CITY OF PORTLAND, MAINE

AGENDA PORTLAND PLANNING BOARD MEETING

Memorandum
Planning and Urban Development Department

To: Chair Stanley & Members of the Planning Board
From: Charles Tetelman
Date: July 8, 2022
Re: 73 Powsland Street
Project ID: PL-0001808-2021
CBL: 190 K015001, 190 K009001, 190 K010001
Meeting Date: July 12, 2022

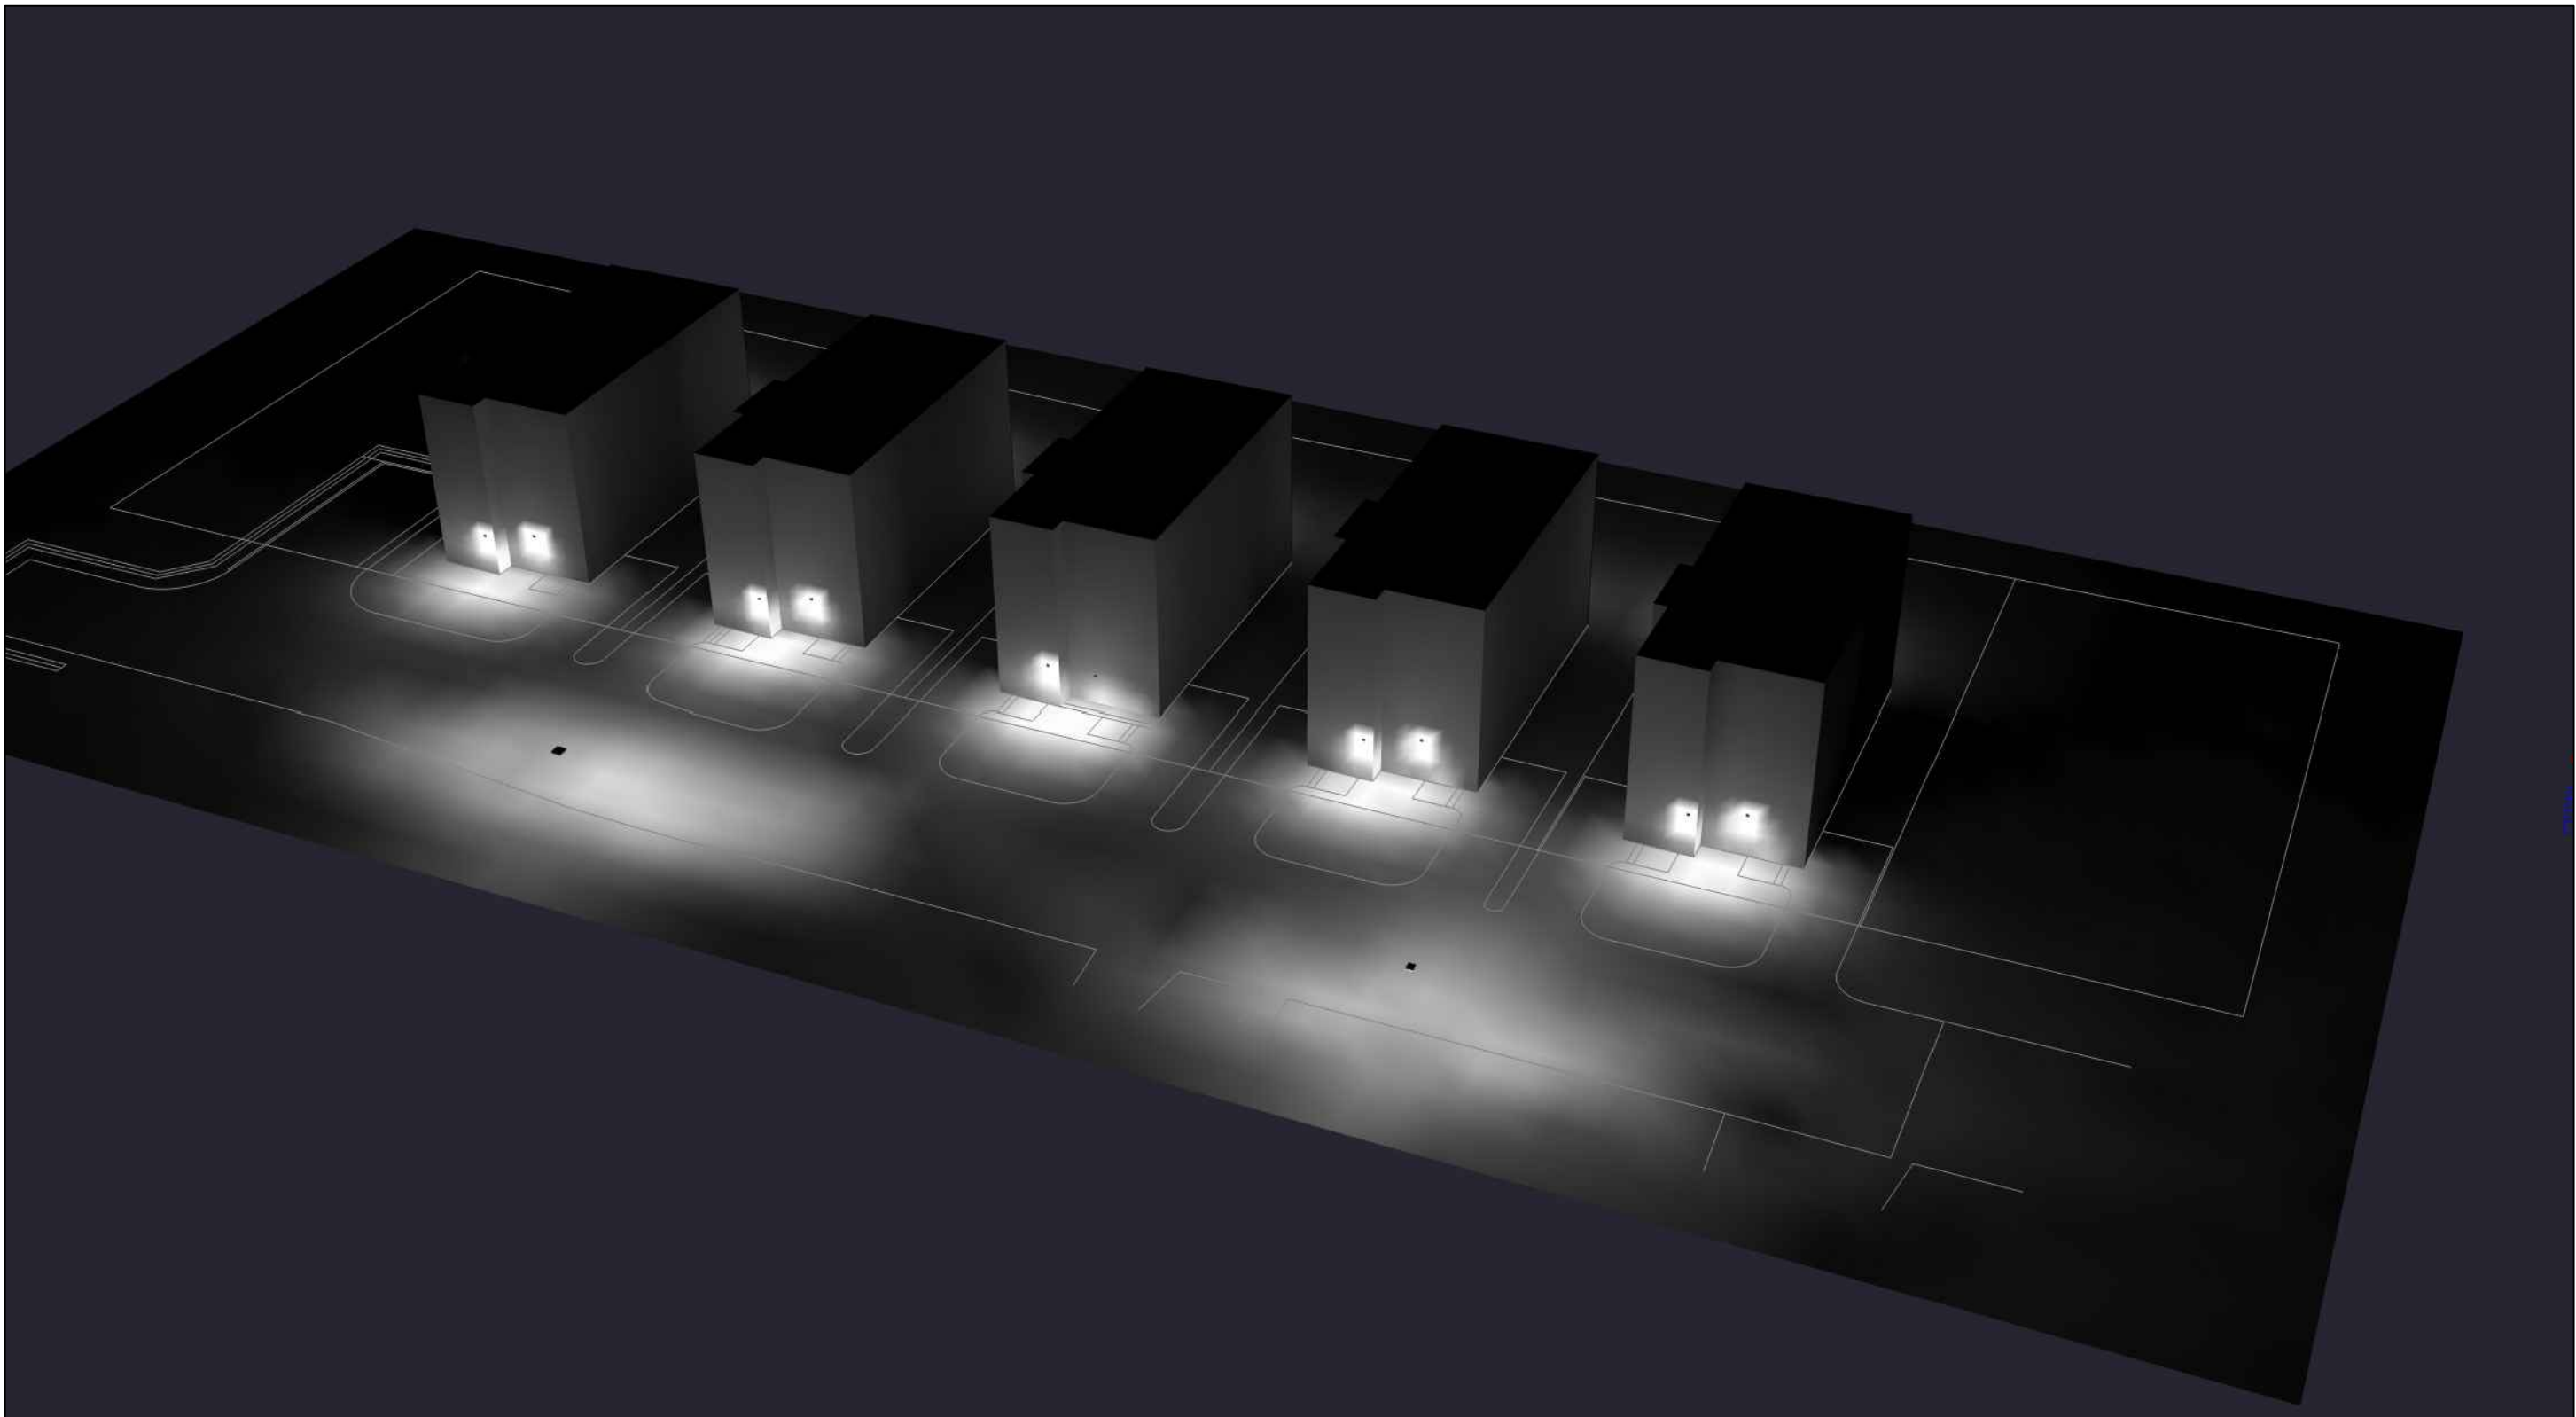
No onsite light fixtures are currently proposed. Lighting will be affixed to the residential buildings. No photometric plan has been submitted as part of this application.
